2.5 Geology, Seismology, and Geotechnical Engineering

In Section 2.5, “Geology, Seismology, and Geotechnical Engineering,” of the site safety analysis report (SSAR), the applicant described the geological, seismological, and geotechnical engineering properties of the early site permit (ESP) site. SSAR Section 2.5.1, “Site and Regional Geology,” describes the basic geological and seismological data for the site and region surrounding the site. SSAR Section 2.5.2, “Vibratory Ground Motions,” describes the vibratory ground motion for the ESP site through a probabilistic seismic hazard analysis (PSHA) and develops the safe-shutdown earthquake (SSE) ground motion. SSAR Section 2.5.3, “Surface Faulting,” describes the potential for surface faulting at or near the surface of the ESP site. SSAR Section 2.5.4, “Stability of Subsurface Materials and Foundations,” presents information on the stability of the ESP site’s subsurface materials. SSAR Section 2.5.5, “Stability of Slopes,” defers the analysis of slope stability to the combined license (COL) application. Similarly, SSAR Section 2.5.6, “Embankments and Dams,” defers the reanalyses of the Clinton Power Station (CPS) ultimate heat sink

Figure 2.5.2-17 Seismic core damage in terms of mean ground motion recurrence interval for EGC ESP site and 25 nuclear power plants. For comparison, FOSID is also shown.

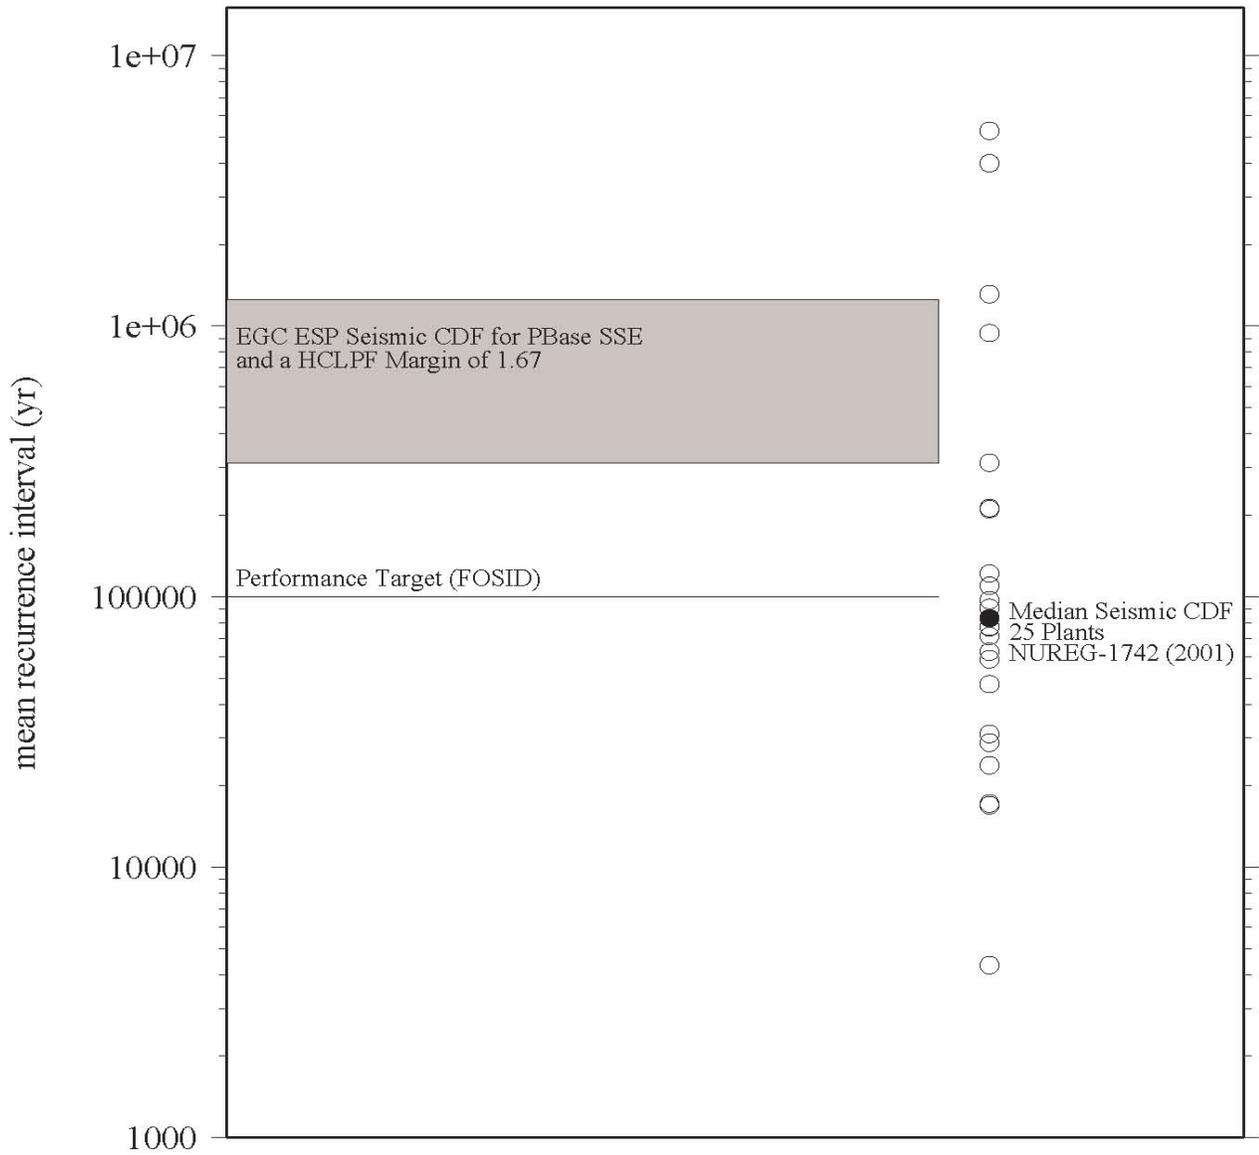
In conclusion, the staff has determined that there is a significant difference between OSID, which is set at $10^{-5}/\text{yr}$ as the target performance goal, and seismic core damage. This result follows from assuming that the seismic margin against core damage is 1.67 as specified in SRM, dated July 21, 1993, on SECY 93-087.

Figure 2.5.4-2 G/G_{max} plot resonant column and cyclic torsion test results

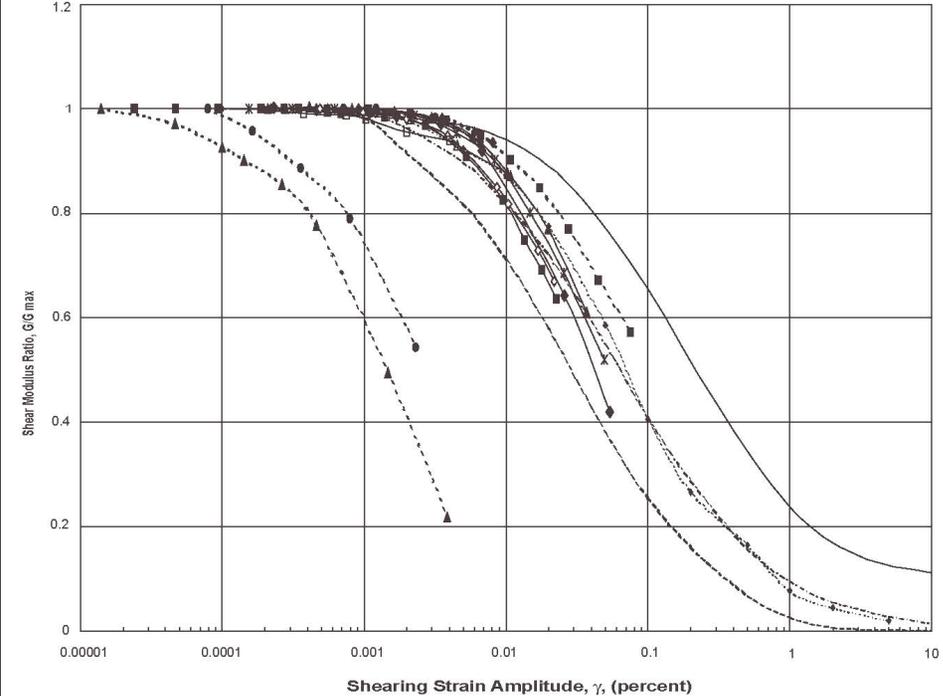
In RAI 2.5.4-2, the staff asked the applicant to justify its use of the EPRI curves and to further explain its basis for concluding that the ESP site soils are consistent with those used to develop the EPRI curves. In response to RAI 2.5.4-2, the applicant stated that the EPRI curves it used represent soils in the general range of gravelly sands to low-plasticity silty or sandy clays and that soils at the ESP site fall within this category of soils. SER Section 2.5.4.3.2 provides a complete description of the applicant's response to RAI 2.5.4-2 and the staff's evaluation of this response.

The information in Figure 5-21 (SSAR Appendix A) does indeed suggest that the hysteric damping from the laboratory tests was higher than the EPRI curves.

The same conclusion can be made from the information in Figure 5-24. However, the curves that are above the EPRI damping curves are related to the resonant column tests. The fact that the resonant column data shown in Figures 5-21 and 5-24 are solid, bold lines masks the response from the torsional shear tests—suggesting that all the damping values are too high at low shearing strain amplitudes. However, material damping values from the torsional shear tests are consistent with the EPRI damping curves, as shown in Figures 4.2-2 through 4.2-6 of Appendix B to the EGC ESP SSAR.
